# Amendment Report

<b>Licence Number</b>	L8889/2015/1
<b>Licence Holder</b>	Eastern Metropolitan Regional Council
<b>ACN</b>	N/A
<b>File Number:</b>	DER2015/000777-1
<b>Premises</b>	Red Hill Waste Management Facility Legal description – Lot 1 Diagram 15239, Lot 2 on Diagram 68630 and Lot 11 on Diagram 69105 Toodyay Road Red Hill and Lot 12 on Plan 26468 Toodyay Road, Gidgegannup
<b>Date of Report</b>	30/03/2020
<b>Status of Report</b>	FINAL

Figure 1: Premises layout

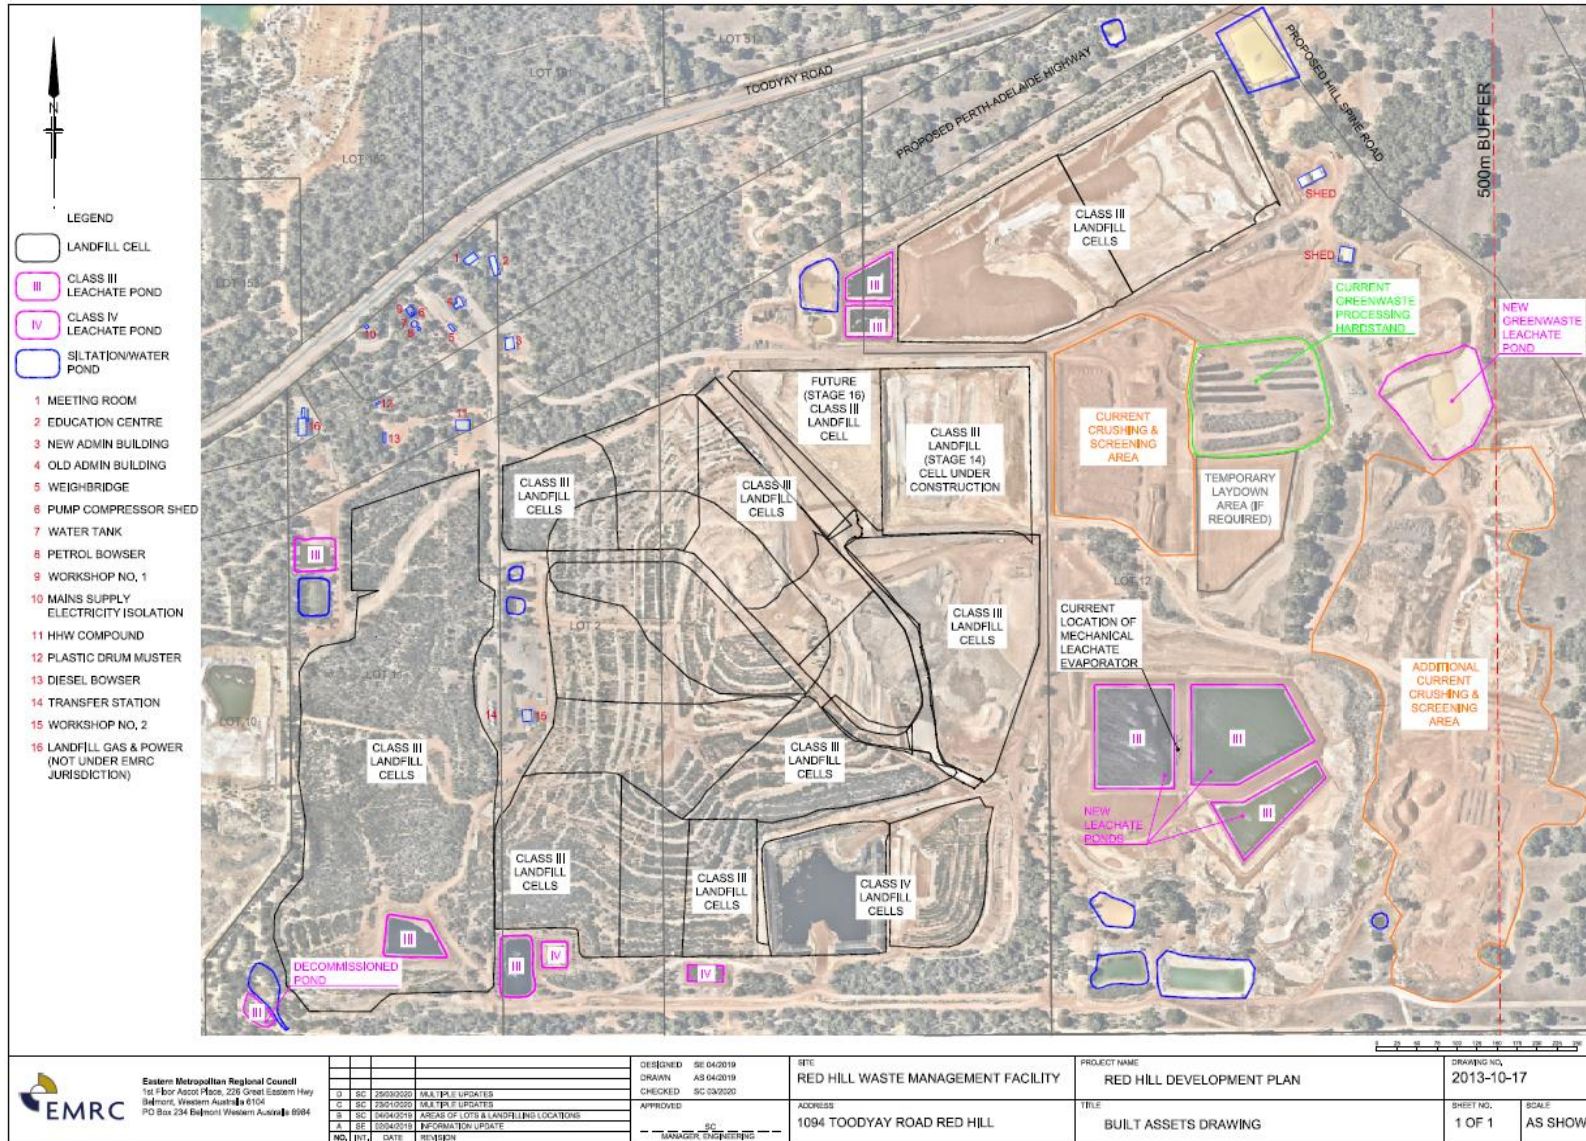
Condition	Item	Summary of Licence Holder comment	DWER response
4, Table 2 and Schedule 1	Infrastructure and equipment locations	The Licence Holder provided an updated Figure 2 as requested with all infrastructure labelled appropriately.	<p>Figure 2 in the licence was updated with the new figure provided by the Licence Holder (Figure 1 in the Amendment Report).</p> <p>The Delegated Officer notes that the location of the 'current green waste processing hardstand' depicted in the Premises layout map shows:</p> <ul style="list-style-type: none"> <li>i) Green waste processing activities at the Premises have moved from the former facility on Lot 1 to the new hardstand on Lot 12. DWER is assessing this operational change and new infrastructure under a separate licence amendment application currently underway for the interim FOGO facility.</li> <li>ii) The new hardstand on Lot 12 has been extended to the south compared to that proposed by the Licence Holder in the separate amendment application. Based on aerial imagery, it appears the Licence Holder undertook these works in late 2019. The Licence Holder has not previously notified or obtained a works approval from DWER to construct this infrastructure. DWER currently has no information about the construction specifications of the extended area. The adequacy of the expanded infrastructure will be assessed under a separate licence amendment application currently underway for the interim FOGO facility. The extended portion of the hardstand has not been assessed or approved by DWER and has therefore been removed from the Premises layout map (Figure 2 in the licence).</li> </ul>

**Figure 13: February 2019 aerial photography showing mechanical evaporation plume and fallout area.**

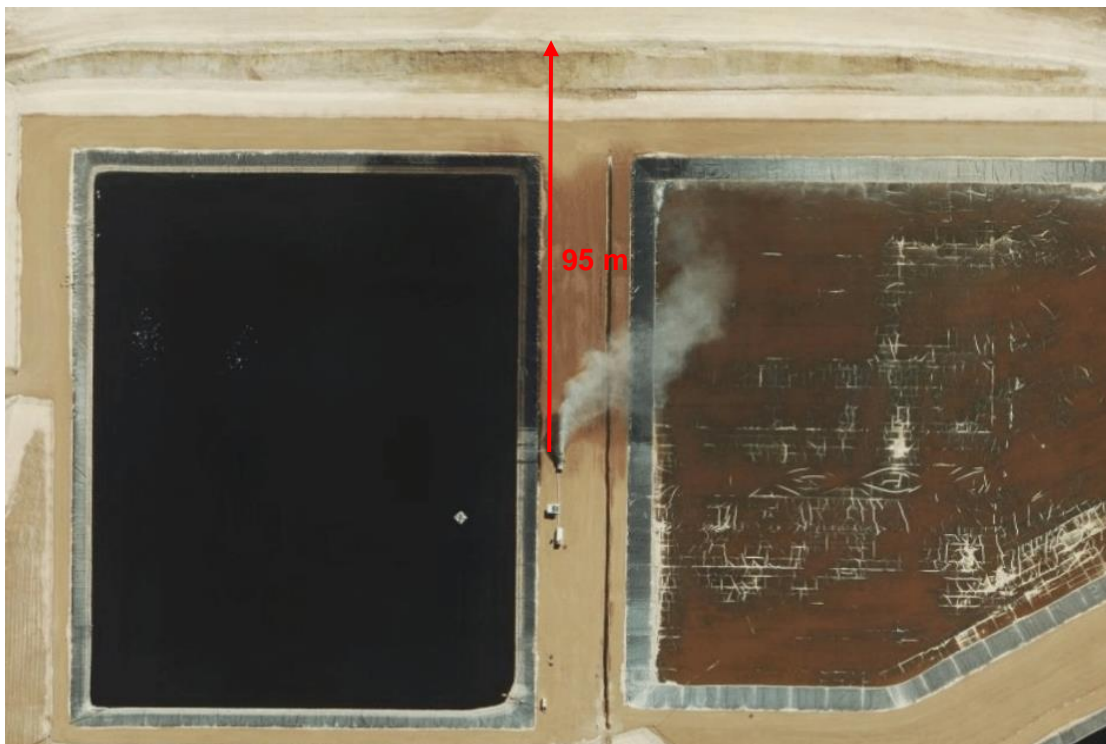
Aerial photography of the Premises (Figure 13) shows that the mechanical evaporator is not oriented to emit over the leachate holding pond. This causes deposition of leachate onto the ground surface resulting in a visibly wet area between the leachate holding pond and the adjacent evaporation pond.

4, Table 2	Mechanical evaporator siting	<p>The Licence Holder proposes to keep the mechanical evaporator in its current location, between the Class III leachate holding pond and adjacent evaporation pond and oriented to spray towards the north. The Licence Holder stated that this fixed location was determined by the most common wind conditions and would allow the spray to be directed into the main holding pond or adjacent evaporation pond.</p> <p>The programming within the weather station is such that a change in conditions is consistent over a short period of time before the evaporator is</p>	<p>The Delegated Officer understands that a closed-loop configuration may not be achievable 100% of the time due to changeable wind conditions and gusts of wind causing overspray. However, the primary concern of the Delegated Officer is that the current orientation of the mechanical evaporator directs the water droplet plume to the north, rather than into the leachate holding pond to its west. Deposition of leachate over the ground surface between and around ponds is expected to lead to the potential accumulation of contaminants within the soil.</p> <p>While the site is operational as a waste management facility, accumulation of contaminants in onsite soil is not considered to present a complete source-pathway-receptor risk event. The only direct receptors to soil contamination on an operational site are staff, contractors and visitors who are not</p>

Condition	Item	Summary of Licence Holder comment	DWER response
N/A – Relates to Amendment Report	Buffer zone and exclusion zone around the mechanical evaporator	<p>The Licence Holder requested that the Delegated Officer reconsider the increase to the buffer around the perimeter of the leachate holding pond from a 150 m to a 300 m radius around the evaporator. Figure 7 in the draft Amendment Report shows the plume and the fallout of leachate created by the evaporator. Given the statement that visual observations indicate that the evaporation plume extends approximately 100 – 150m from the evaporator, then why is the arbitrary number of 300m being applied?</p> <p>The Licence Holder requested an explanation of the science and rigour behind the imposition of doubling the buffer to a 300m radius. This is a significant change to the current buffer and has significant flow on impacts on the ability of the site to operate with this limitation. The running of the evaporator is governed by the weather station parameters. These are set to allow little to no drift outside the hold pond or evaporation ponds. Any drift which does fall outside the ponds is directed to flow back into the ponds via drainage structures. The perimeter fence surrounding the ponds serves as the ideal buffer distance whilst the evaporator is in operation. This fence is gated and locked at all times. If access is required the evaporator is shut down by the supervisors to allow access. If imposed, the 300 m buffer would impact on a majority of the working area of the</p>	<p>The 300 m buffer distance discussed in Section 0 was not intended to act as an exclusion zone for site personnel, contractors and visitors. As discussed in Section 6, these receptors are not considered in DWER’s risk assessment as they are covered under other legislation.</p> <p>The 300 m buffer distance referenced in Key Finding (20) and shown in Figure 14 was used to understand the likelihood of offsite dispersal of the evaporation plume. Although the plume had been observed to be 100-150 m in radius based on visual observations, there was some uncertainty as to the full extent of the non-visible component of the evaporation plume. The Delegated Officer used the 300 m buffer distance to the site boundary to justify that there was sufficient conservatism in the risk assessment, despite this uncertainty.</p> <p>Key Finding (20) has been edited to provide clarity on this matter.</p>
